Figure 1: Myotis macropus records from OEH Bionet Atlas.

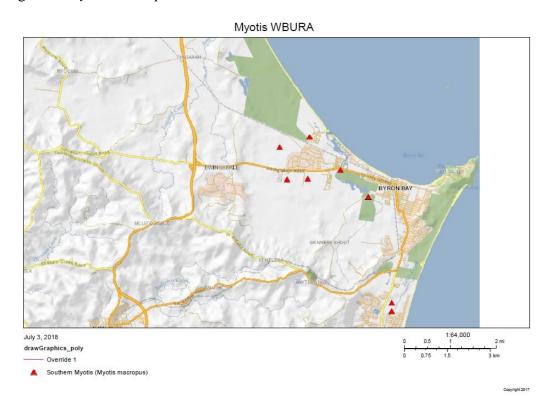
The Threatened Species Management Plan (TSMP) restricts its considerations to 13 species which have been recorded at the site. It omits to consider the threatened Southern Myotis or fishing bat *Myotis macropus* which is recorded from 2 locations in the WBURA, and which is likely to forage along the main drain (see Figure 1). By limiting its scope to threatened species recorded at the WBURA site, the threatened estuarine wading birds of Belongil Creek and its near vicinity are omitted from consideration. Appendix A lists the 64 threatened fauna species recorded from a 10km by 10km area with the WBURA at its centre, and some of these species are likely to occur at times on the WBURA site, but are not considered *e.g.* Pale-vented Bush-hen, Common Planigale.
